## Product Change Notification

TRIMPOT® TRIMMING POTENTIOMETERS

### Bourns® Trimpot® Product Line Announces Models **3214** and **3224** Product Change

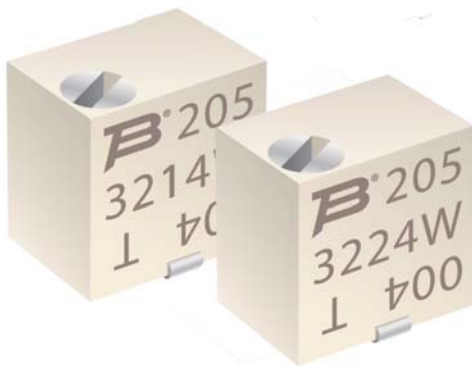
Bourns® Trimpot® Product Line has updated the material used for these models. This material is an engineered plastic that does not contain halogen compounds to assist in the retardation of flammability. These products are the first of many products that we will be converting to become “halogen free.”\*

Both plants (Taiwan and Costa Rica) will begin the conversion on April 1, 2011. The effective date code will read 114. This change does not affect form, fit or function of the product. There will be a color difference.
